MFN 06-239

Subject: **Additional Information to Support Draft RAI 21.6-53**

**Material Properties for the Sodium Pentaborate
Standby Liquid Control System Injection Liquid**

RAI 21.6-53 A (Draft)

Figure 21.6-53-1 Density Curve of Sodium Pentaborate Solution

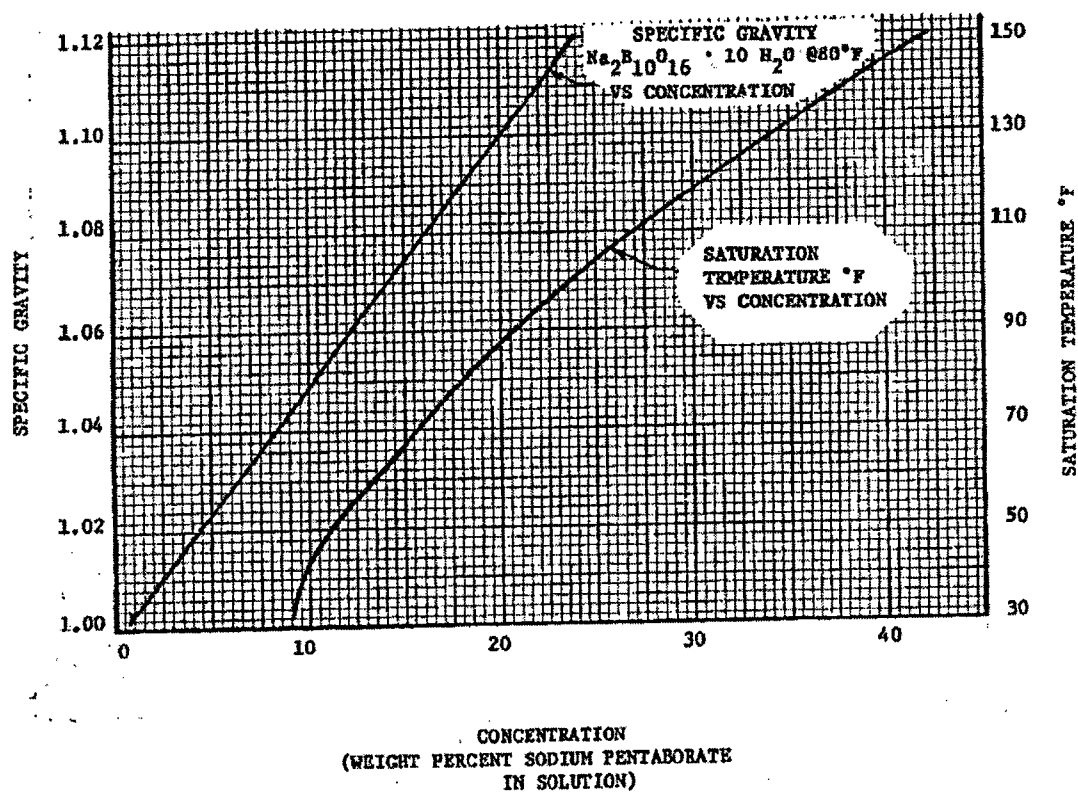
Material properties for the sodium pentaborate standby liquid control system (SLCS) injection liquid: (T) (density as a function of temperature), C_p (specific heat capacity), k (thermal conductivity), (viscosity), and mass diffusivity. The staff needs the density as a function of temperature. If available, the staff would also prefer the other properties as a function of temperature.

The relative density (specific gravity) as a function of concentration at 80°F is provided in Figure 21.6-53-1. A good approximation of the specific gravity at other temperatures can be found by assuming that the change in the specific gravity of the solution with temperature is proportional to that of water. Though figure 21.6-53-1 is for sodium pentaborate with natural boron, the change in the density curve for ESBWR enriched boron is insignificant.
